Notice of Meeting
Polk City | Planning and Zoning Commission (P&Z)

SITE PLAN REVIEW

Date: November 16, 2022
 Project: Lake Front Office Park – Lot 1

PLAT OF SURVEY IN 2-MILE EXTRA-TERRITORIAL AREA

LAKE FRONT OFFICE PARK LOT 1
UTILITY PLAN

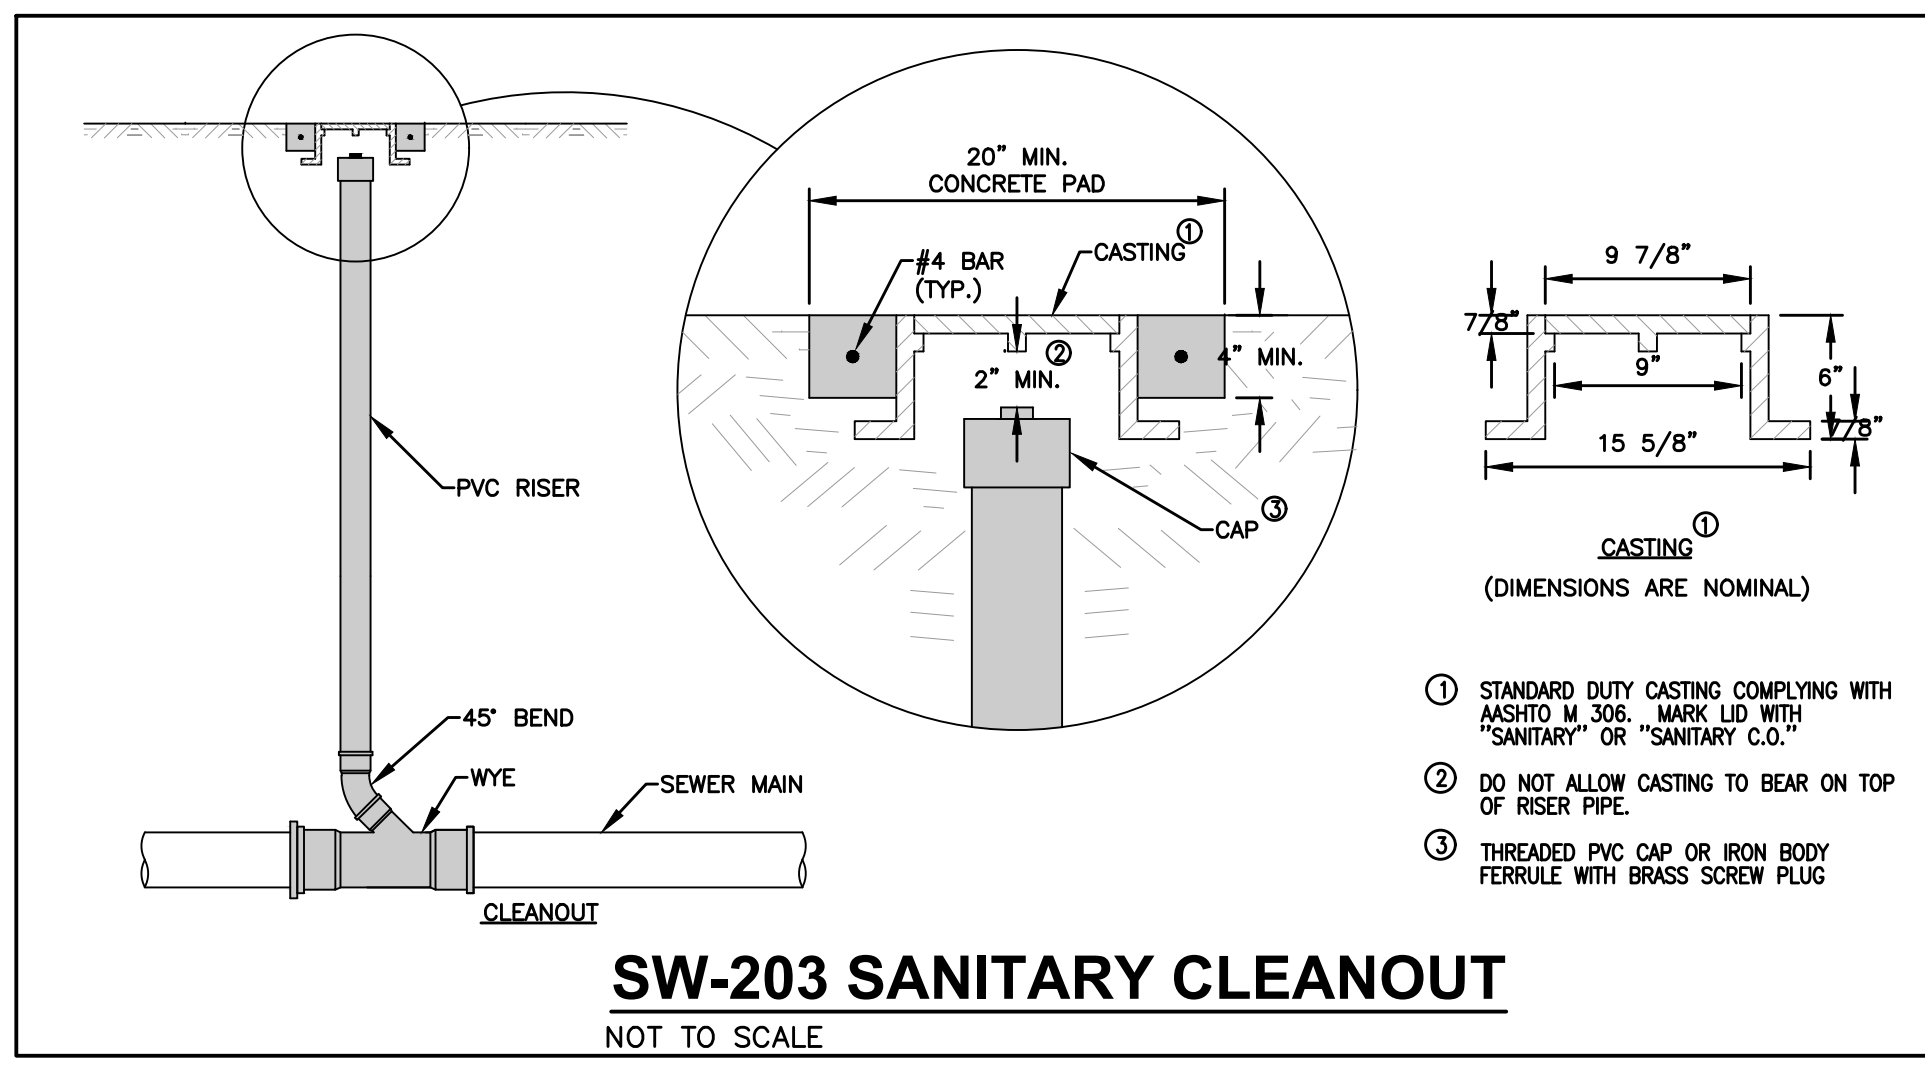
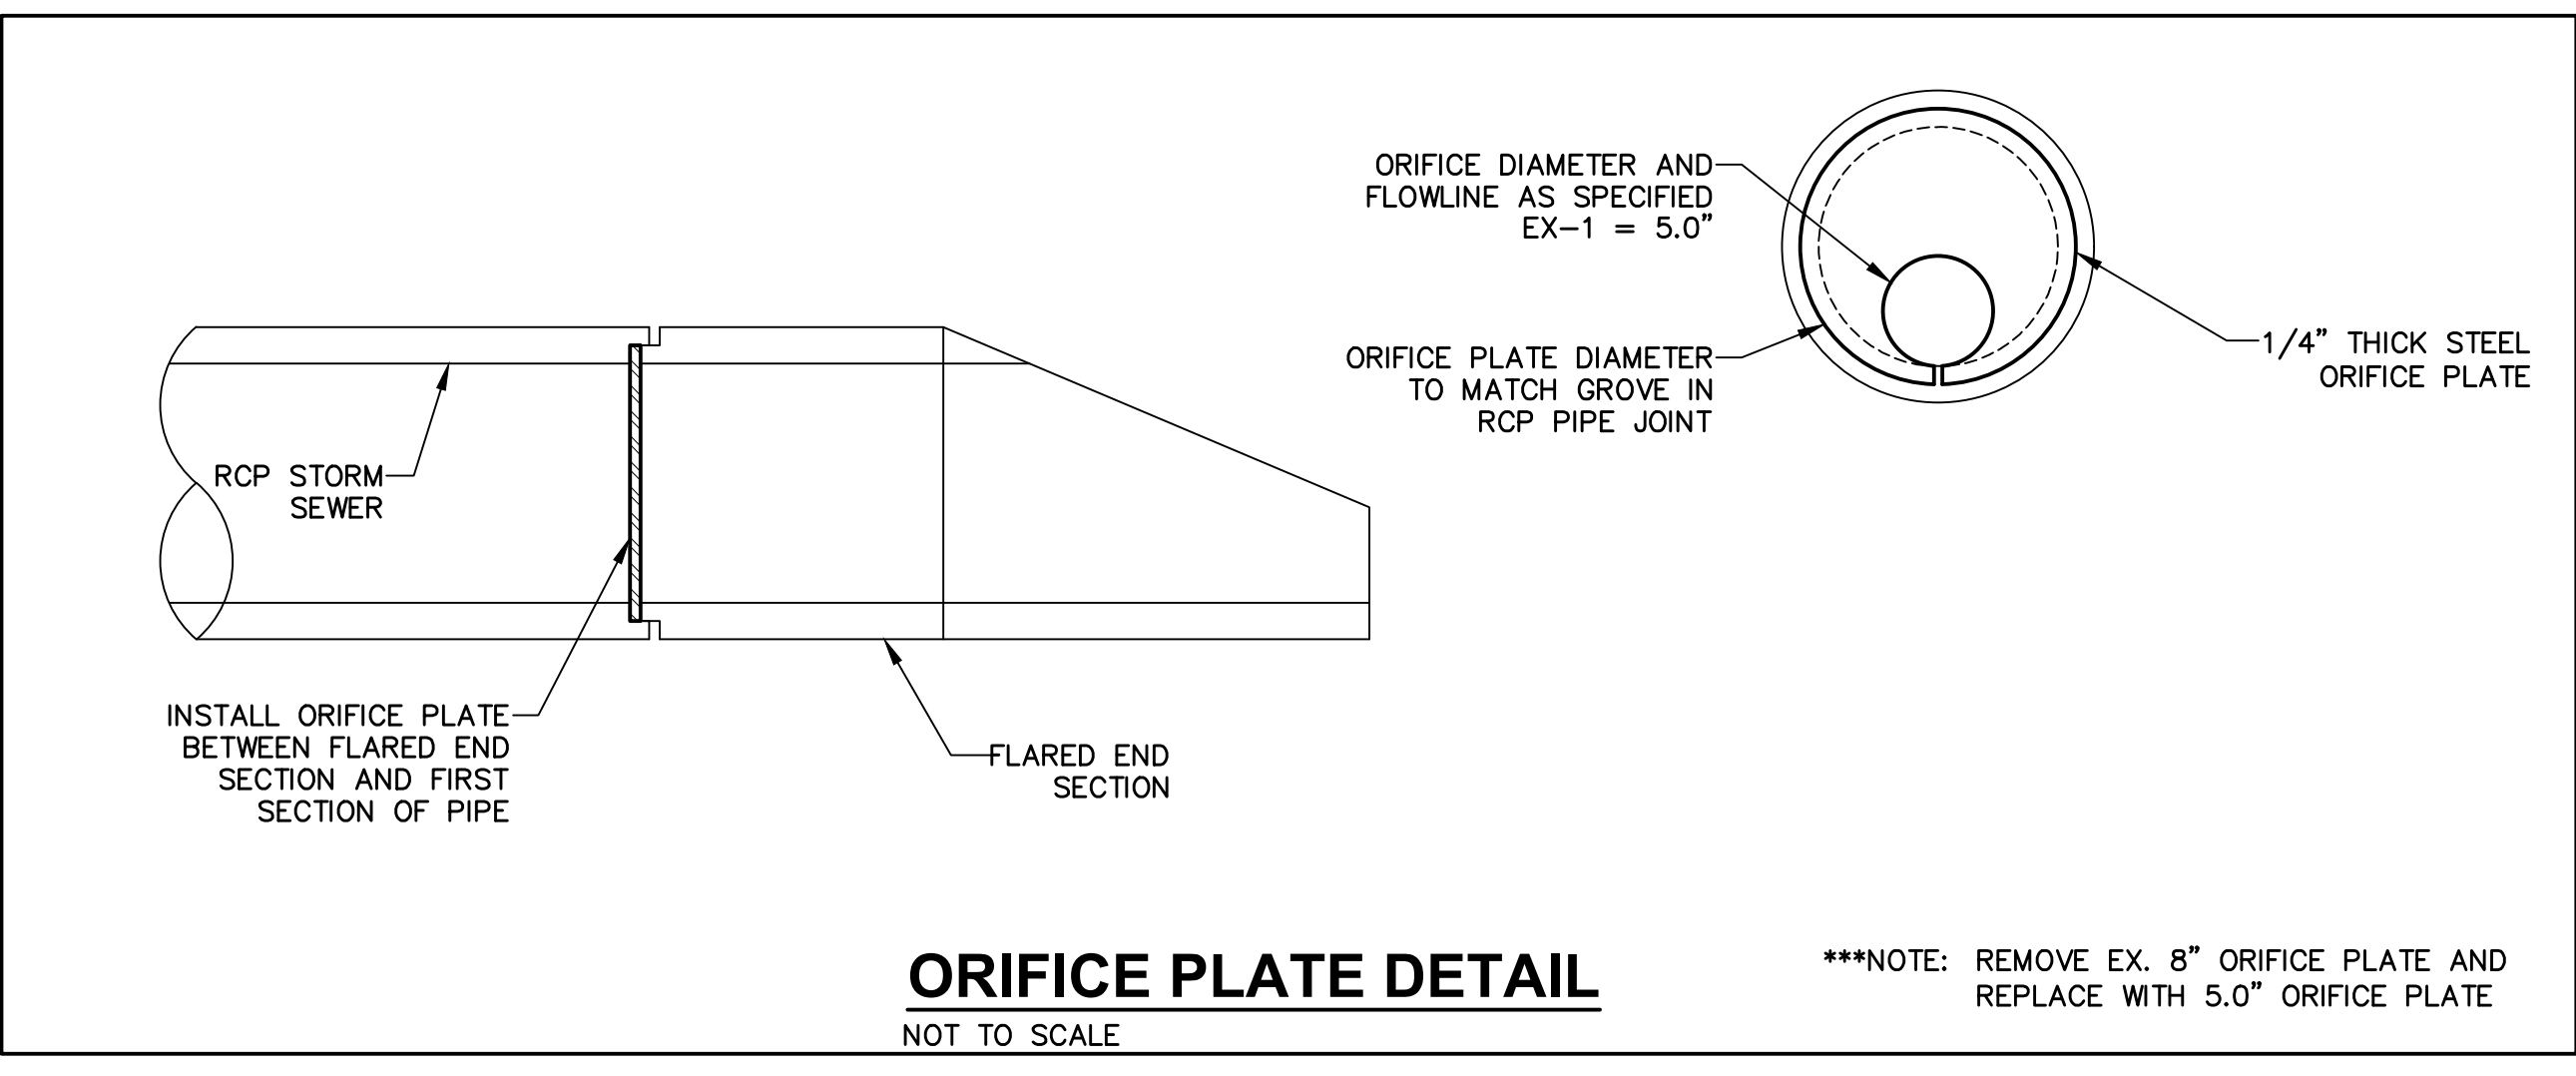
2. Revise Note 19 on the Utility Plan to refer to the “Property Owner” in lieu of “Owner of the Building” per our 11/15/22 email regarding the shared grease trap.
